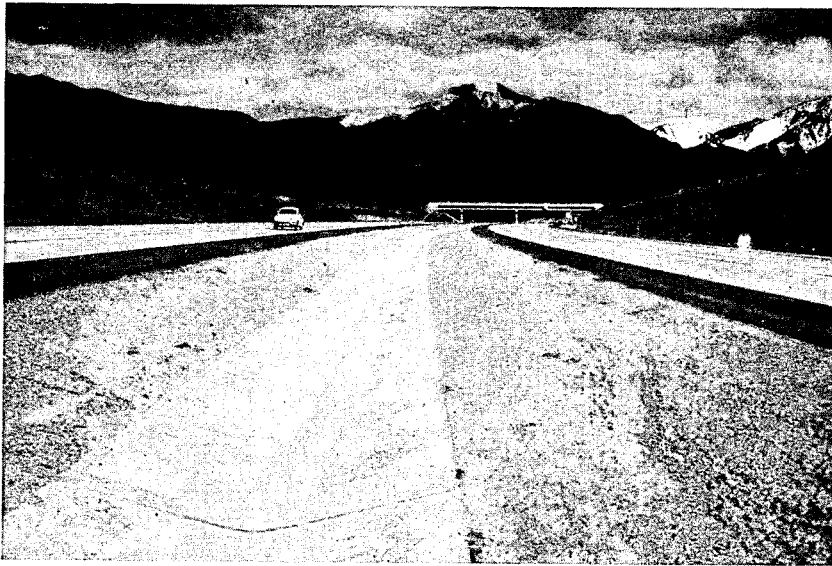
The median drainage is handled in a concrete paved ditch of this sort. Aside from the fact this has a rather sharp V at the bottom, I think it might be regarded as satisfactory.

A rounded bottom would probably be more safe, functionally.

At the side there is a sharper V ditch with a steep back slope, and as you can see, the erosion from this slope is beginning to fill up this particular drainage feature and certainly, from the standpoint of a car running into this type of a break in the slope, this is undesirable.
